DIXON REC OFFICE IMPROVEMENT

PROJECT NUMBER: 2407-22

ADDENDUM NO. 1

Addendum #01

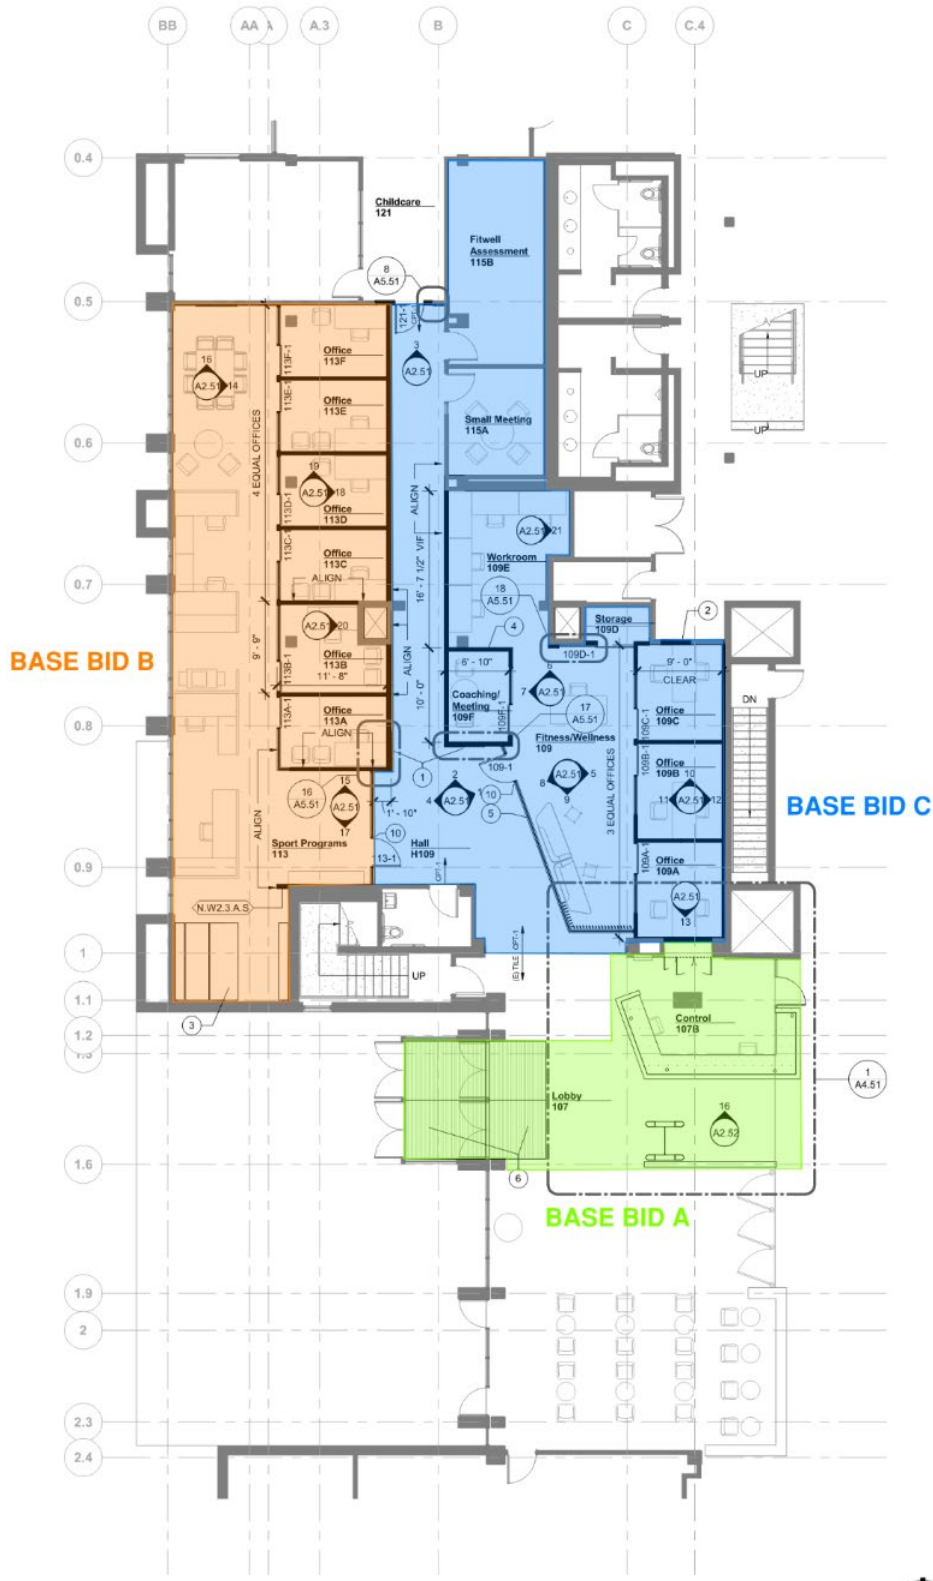
1. *Question:* Please define the areas of West Entry, Sports Program, and Fitness & Wellness Spaces. The plans show this as one consolidated area without a clear distinctions which makes it difficult to accurately breakout pricing for Base Bid A, B, & C.?

Response: Exhibit A + B have been included to more clearly illustrated the scope of work for Base Bids A, B, & C. Base Bid A includes all work in the lobby space and control desk. Base Bid B includes the wall enclosing the Sport Programs Suite and all work west of it on Level 1. Base Bid C includes all Level 1 work east of that wall.

ARRANGEMENTS – MODEL SDR

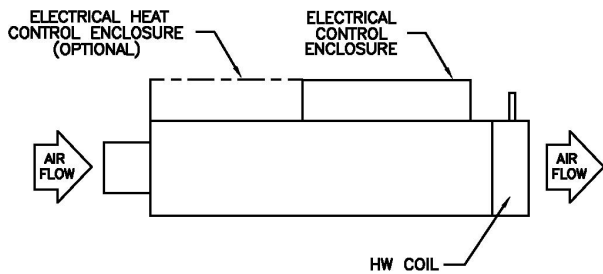
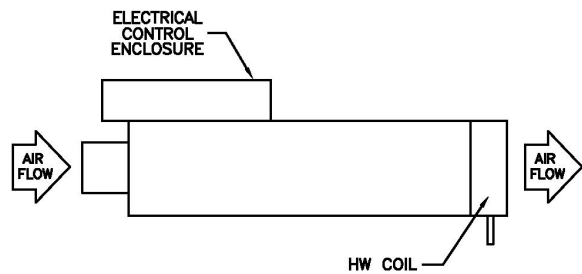
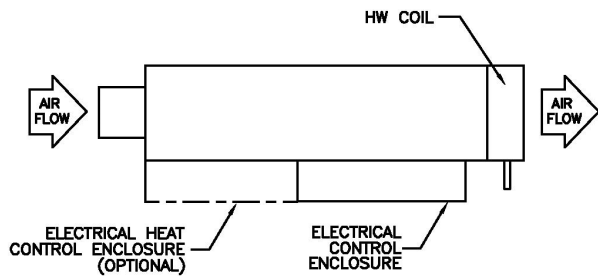
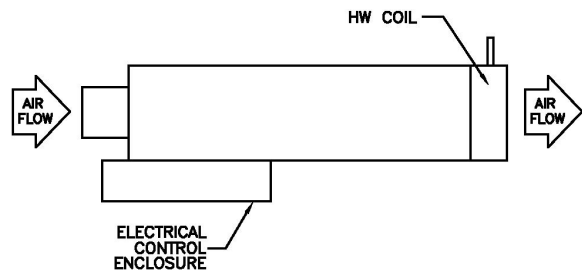
PROPOSED SUBSTITUTION: TU6-110, 111, and 112

Remarks: TU6-111 should be changed to match
TU6-112 at 300 cfm

Attachments: preliminary example submittal included; unable to make selection for TU6-111 with scheduled values.
Please check design parameters.
